**STATE OF TENNESSEE  
DEPARTMENT OF TRANSPORTATION  
ROADWAY DESIGN DIVISION**

**INSTRUCTIONAL BULLETIN NO. 14-08**

**Regarding Revised Standard Drawings**

**Effective for the February 2015 Letting (Dec 3rd turn-in)**, the following Standard Drawings are revised or new. Section V of the Guidelines is also revised effective that date. Standard Drawings **T-S-16A** is voided by this Instructional Bulletin.

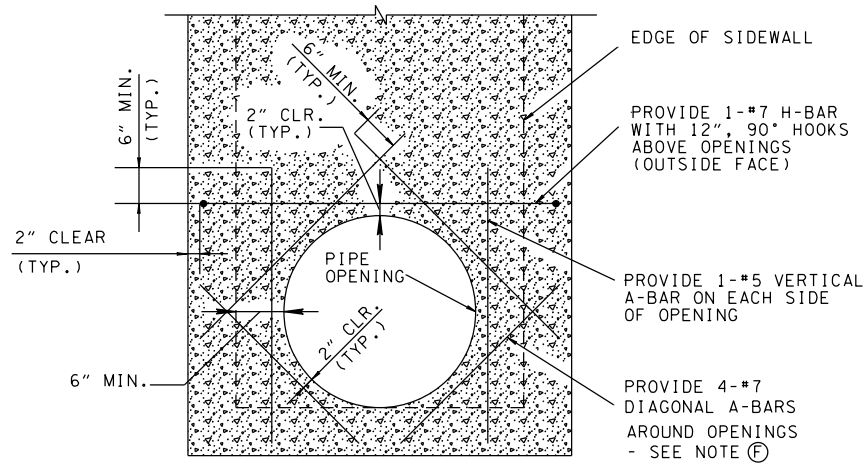
REV. 6-7-13: ADDED NOTES  
 ⓐ, ⓑ, AND Ⓒ  
 REV. 3-11-14: ELIMINATED STIRRUPS.  
 REV. 5-20-14: COMBINED NOTE ⓐ AND Ⓒ

RP-J-7

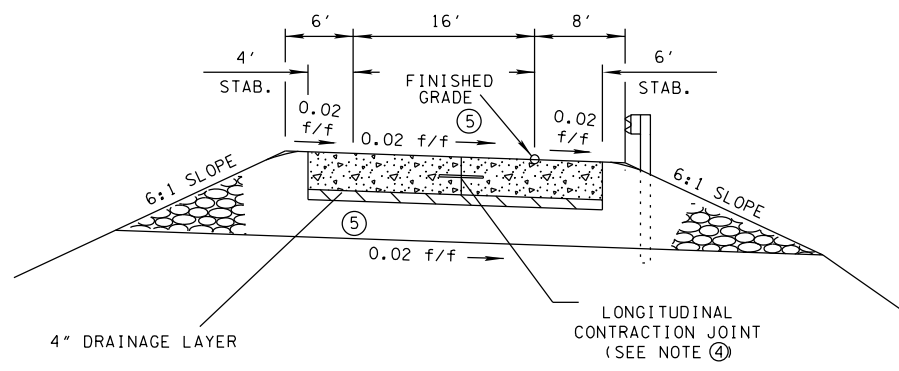
- REV. 1-31-83: ADDED JOINT SKEW NOTE.
- REV. 6-23-88: DELETED JOINT SKEW.
- REV. 3-20-91: REDREW SHEET AND CHANGED JOINT SPACING FOR CONCRETE PAVEMENT USING STONE. ADDED FOOTNOTE NO. ⑦.
- REV. 12-18-94: CHANGED DRAWING REFERENCE NUMBER IN CROSS-REFERENCE BLOCK.
- REV. 10-26-00: CHANGED VARIABLE JOINT SPACING TO 15' CONSTANT.
- REV. 1-30-12: ADDED LONGITUDINAL CONTRACTION JOINT DETAILS.
- REV. 7-14-14: UPDATED DOWEL BAR DETAIL.

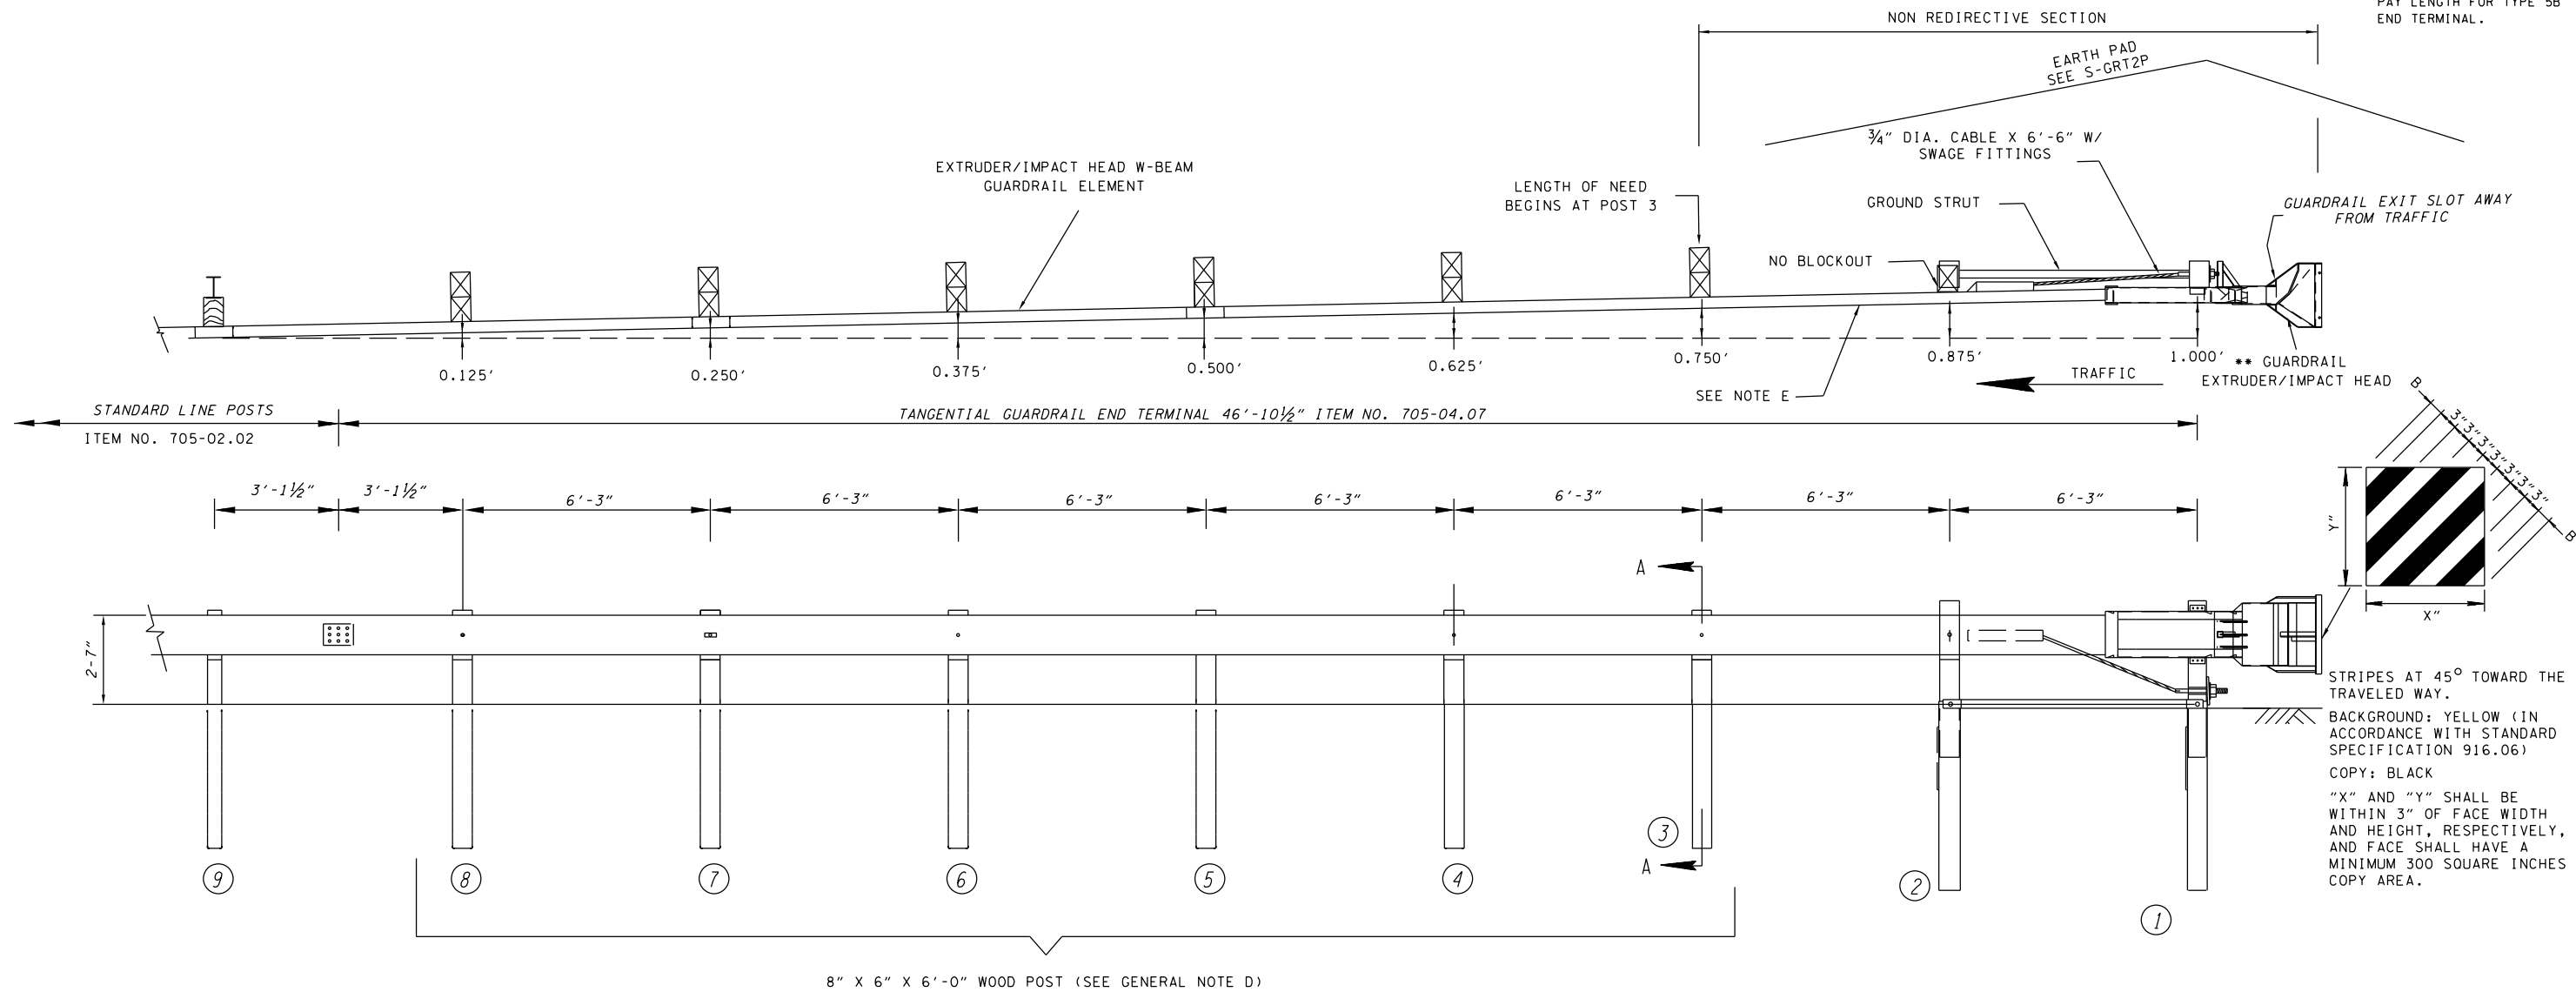
REV. 6-30-14: MODIFIED PAY LENGTH FOR TYPE 5B END TERMINAL.

FOOTING DETAILS  
 FOR OVERHEAD SIGN  
 STRUCTURE 32"  
 MEDIAN  
 BARRIER WALL

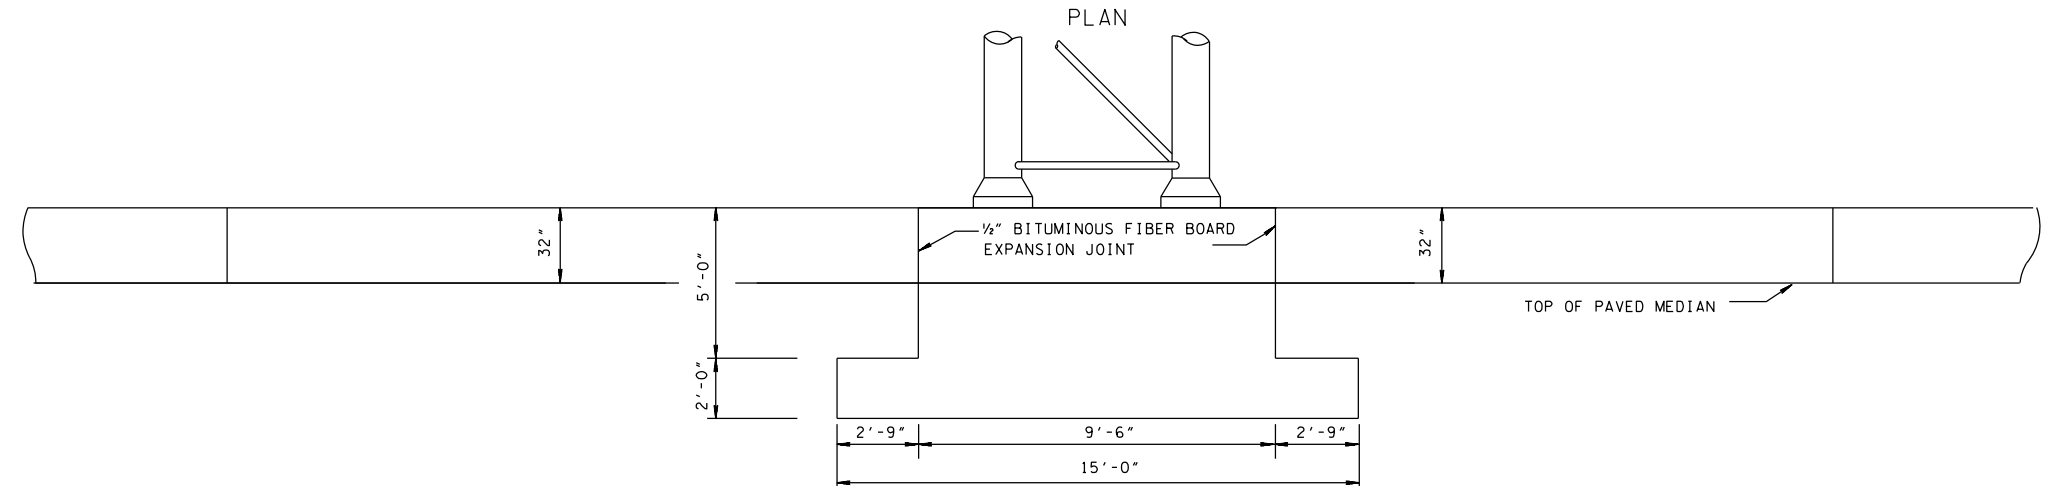
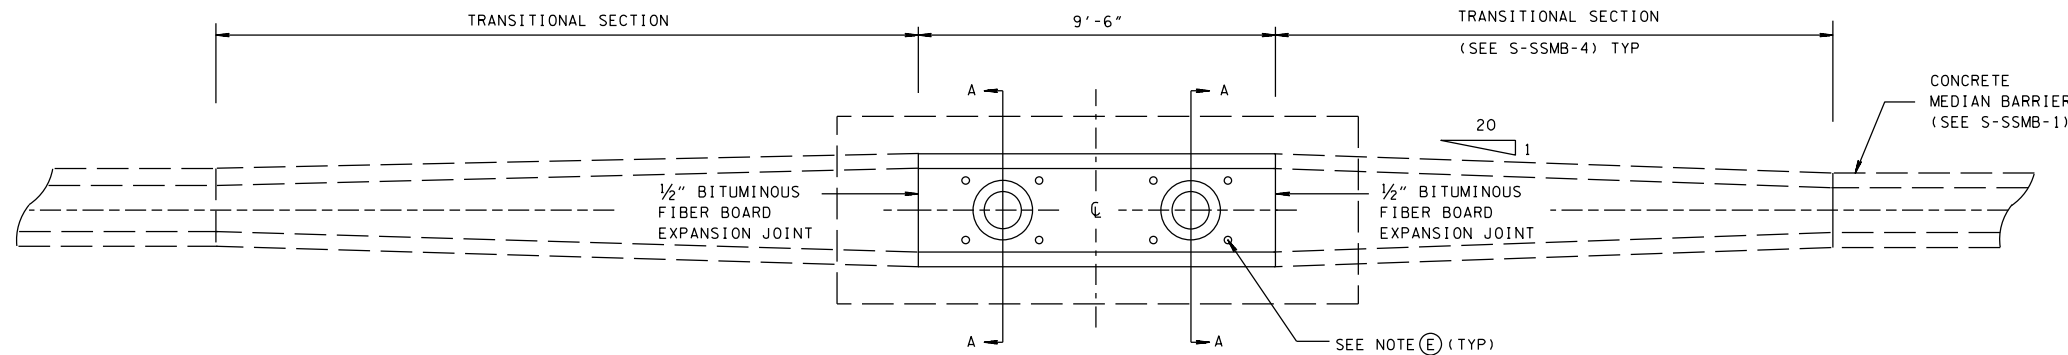
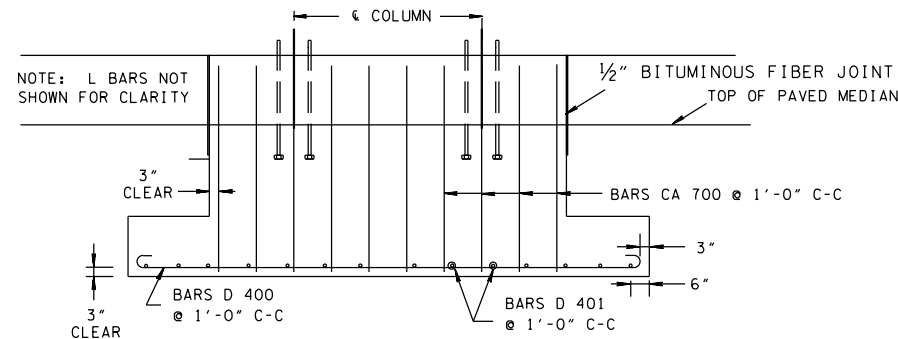
REV. 12-4-13: CHANGED ANCHOR BOLTS TO THREADED.  
 REV. 5-10-14: REVISED BILL OF STEEL.

FOOTING DETAILS FOR OVERHEAD SIGN STRUCTURE 51" MEDIAN BARRIER WALL

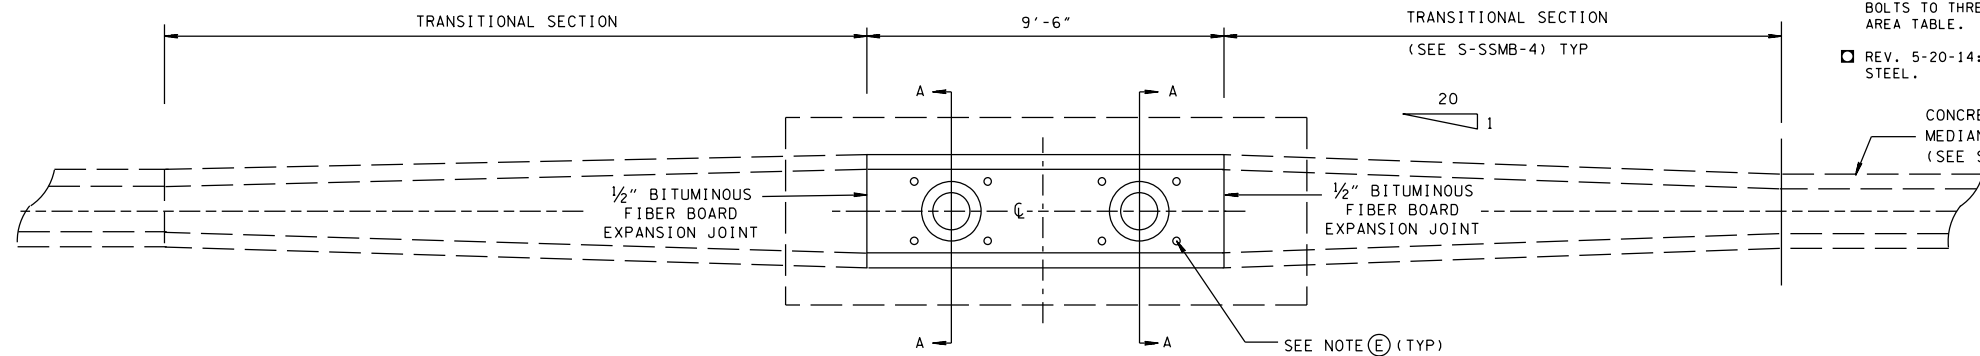
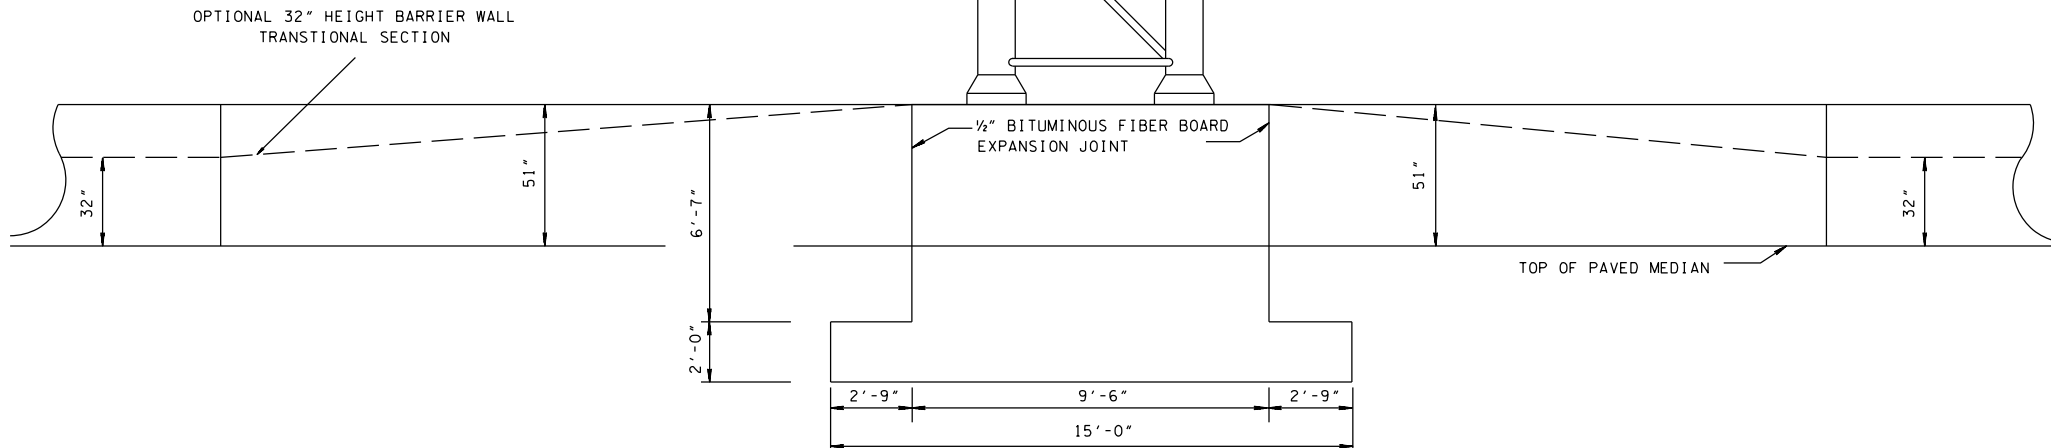
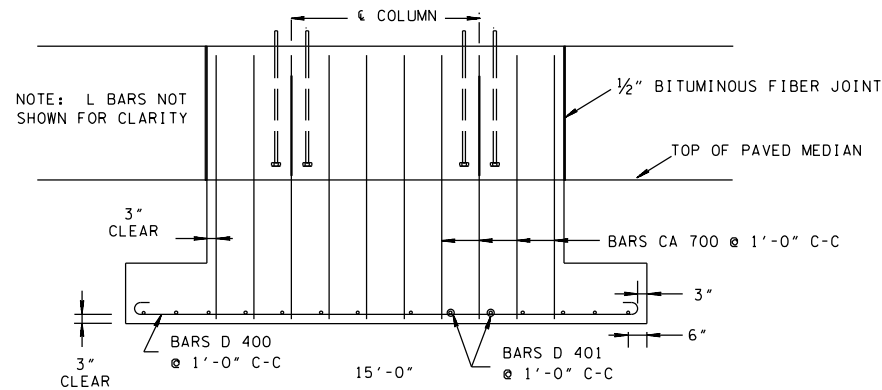
- REV. 12-4-13: CHANGED ANCHOR BOLTS TO THREADED. ADDED BEARING AREA TABLE.
- REV. 5-20-14: REVISED BILL OF STEEL.

T-M-1

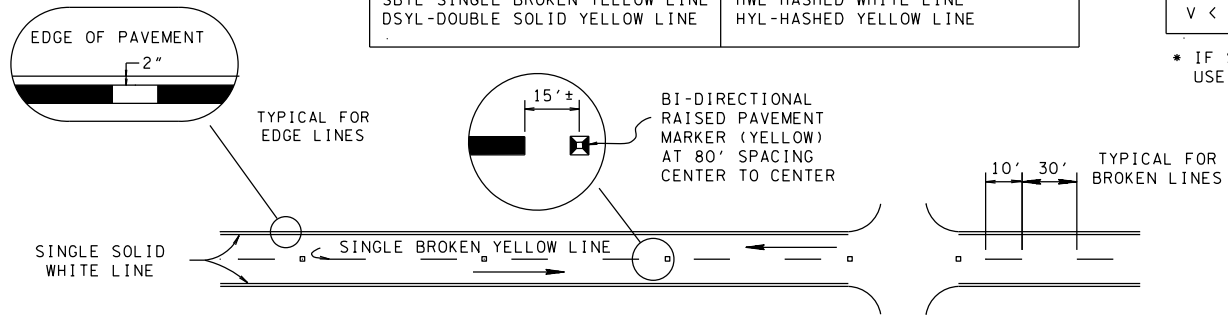
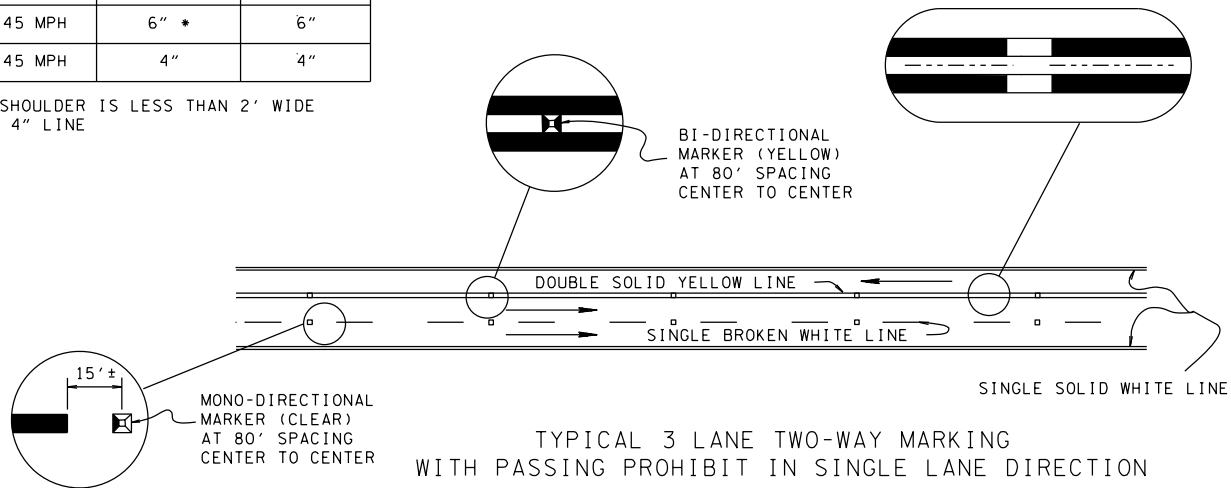
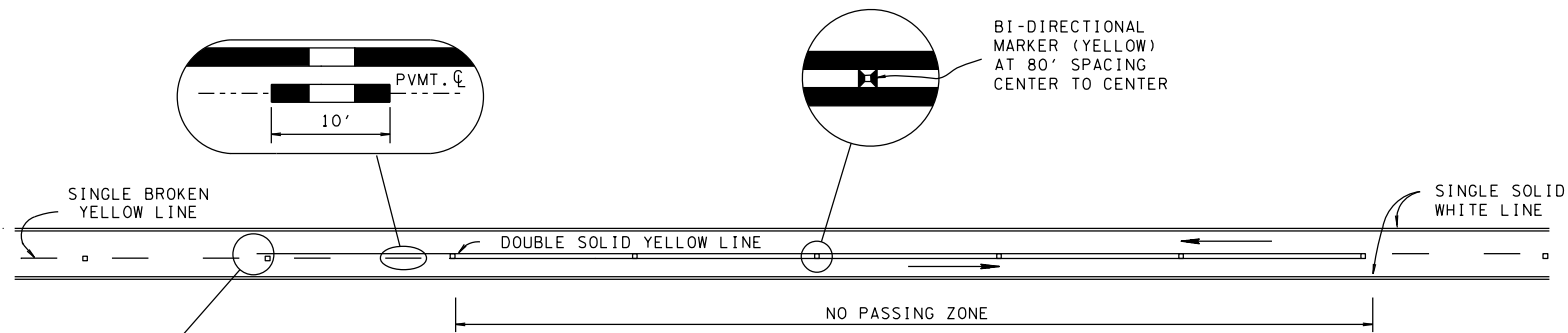
- REV. 2-22-88: ADDED EDGLINES, NOTES AND VARIOUS STRIPING AND MARKING DETAILS. CHANGED DWG. NO. FROM T-M-7 TO T-M-1. CHANGED SPACING & LOCATION OF VARIOUS RAISED PAVEMENT MARKERS. ADDED MARKING ABBREVIATIONS.
- REV. 3-20-91: REDREW SHEET. CHANGED TYPE 2 PAVEMENT MARKERS (CLEAR) TO MONO-DIRECTIONAL PAVEMENT MARKERS (CLEAR) AND CHANGED TYPE 1 PAVEMENT MARKERS (YELLOW) TO BI-DIRECTIONAL MARKERS (YELLOW).
- REV. 10-26-92: ADDED GENERAL NOTE (C).
- REV. 7-29-98: REVISED DISTANCE BETWEEN EDGLINE PAVEMENT MARKING AND EDGLINE FROM 4" TO 2".
- REV. 4-15-04: CHANGED SPACING BETWEEN DOUBLE LEFT TURN ARROWS TO COMPLY WITH 2003 MUTCD.
- REV. 11-1-11: UPDATED TYPICAL DETAILS TO CONFORM WITH 2009 MUTCD STANDARD DETAILS.
- REV. 7-24-14: ADDED PAVEMENT MARKING TABLE.

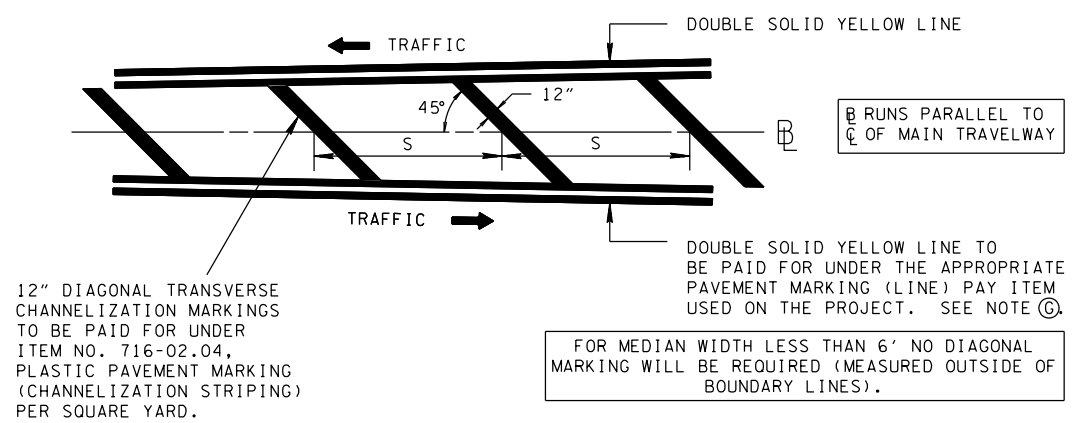
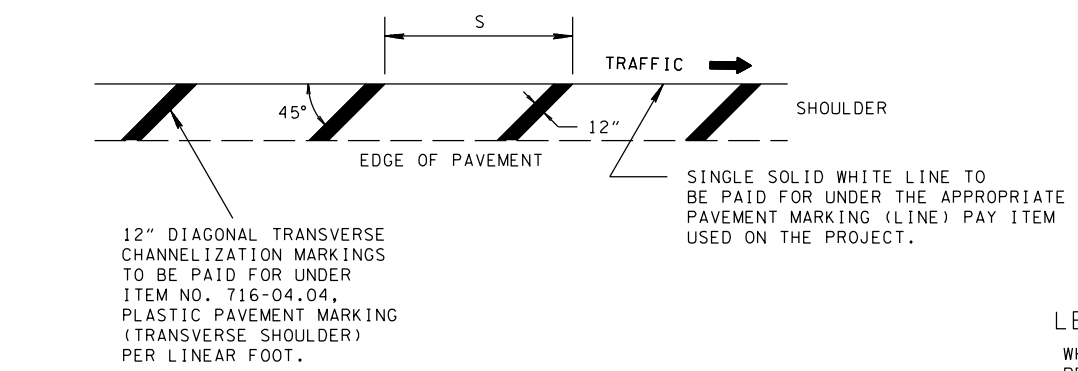
REV. 7-24-14: ADDED GENERAL NOTE ①

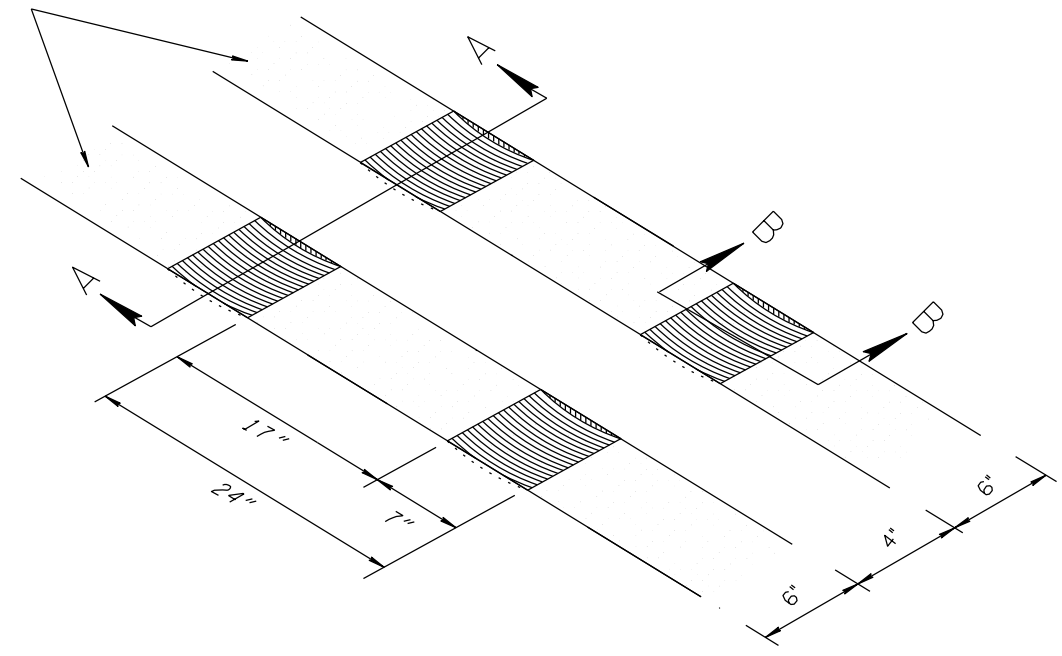
REV. 4-21-14: REMOVED TWO WAY PASSING ZONE OPTION MODIFIED NOTES (A) AND (B).  
 REV. 7-24-14: CHANGED STRIPE WIDTH.
